STATE OF MISSOURI
DEPARTMENT OF NATURAL RESOURCES

OCT 07 2014

RE: Temperature Monitoring and Corrective Action Assessment and Plan--Neck Area,
Bridgeton Landfill, Permit Number 0118912, St. Louis County

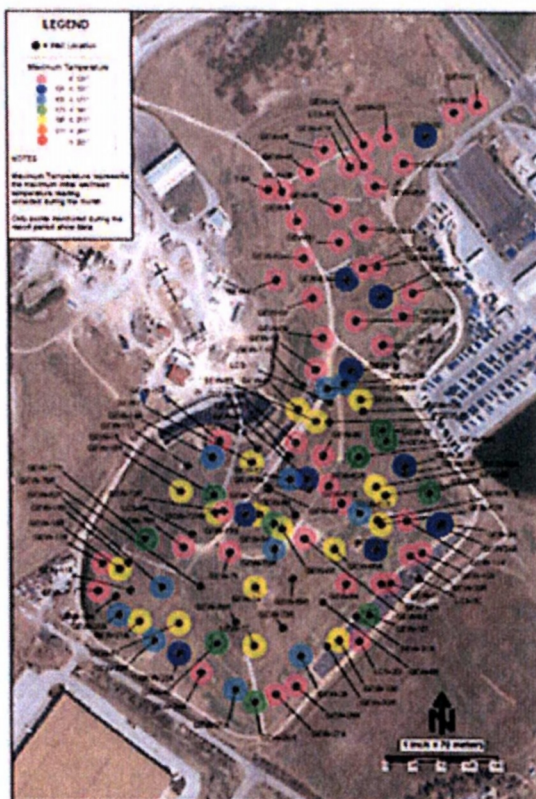
Pursuant to Paragraph 20 of the First Agreed Order, the SWMP is requiring installation of a new line of Temperature Monitoring Probes containing at least twelve (12) (TMP-21 through approximately -33). Installation of the TMPs must begin no later than 30 days from receipt of this letter along a line as specified on the attached map. These new TMPs are necessary as a data gap has been identified existing between the neck area and North Quarry primarily due to continued failure of thermocouples in the current lines of TMPs and specifically, the TMP line including TMP-1, -2, -3 and -4. The new TMPs will ensure the landfill and the SWMP have a system for monitoring temperatures at depth in the landfill and potential impacts from the South Quarry subsurface fire. Upcoming winter weather may preclude construction activity, such as installation of additional TMPs from December through March, and the estimated time for construction of the isolation barrier as noted above has expanded to at least 18 months, necessitating timely completion of these new TMPs to ensure adequate monitoring will continue over the coming months.

BRIDGETON LANDFILL
INITIAL TEMPERATURE MAXIMUM MAY 2014 COMPARED TO AUGUST 2014
SOURCE: MONTHLY REPORTS FILED BY REPUBLIC SERVICES FOR BRIDGETON LANDFILL

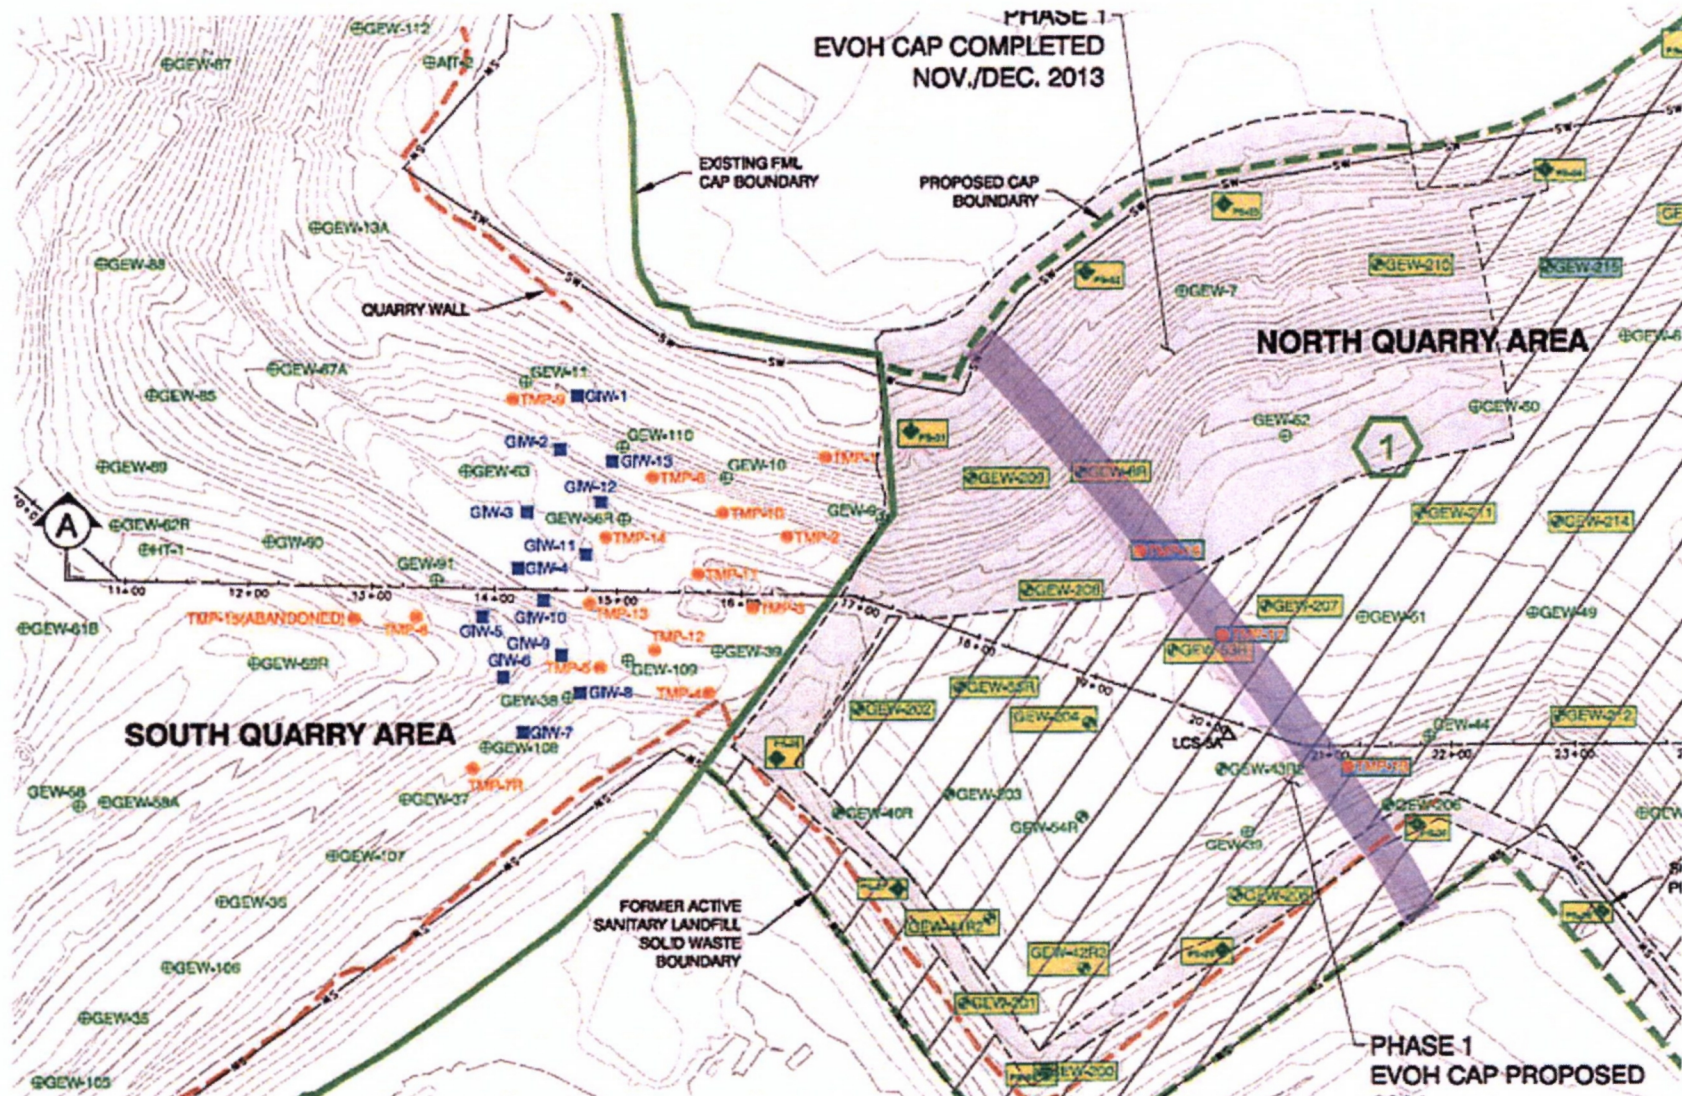
Recent reports by federal agencies indicate the isolation barrier originally contemplated in the North Quarry Action Plan for the Bridgeton Landfill is now likely at least 18 months away from actual construction, i.e., dirt work beginning. As a result and to ensure protection of human health and the environment, beginning October 14, 2014, specific temperature data for the following gas extraction wells is required to be submitted on a weekly basis to the SWMP.
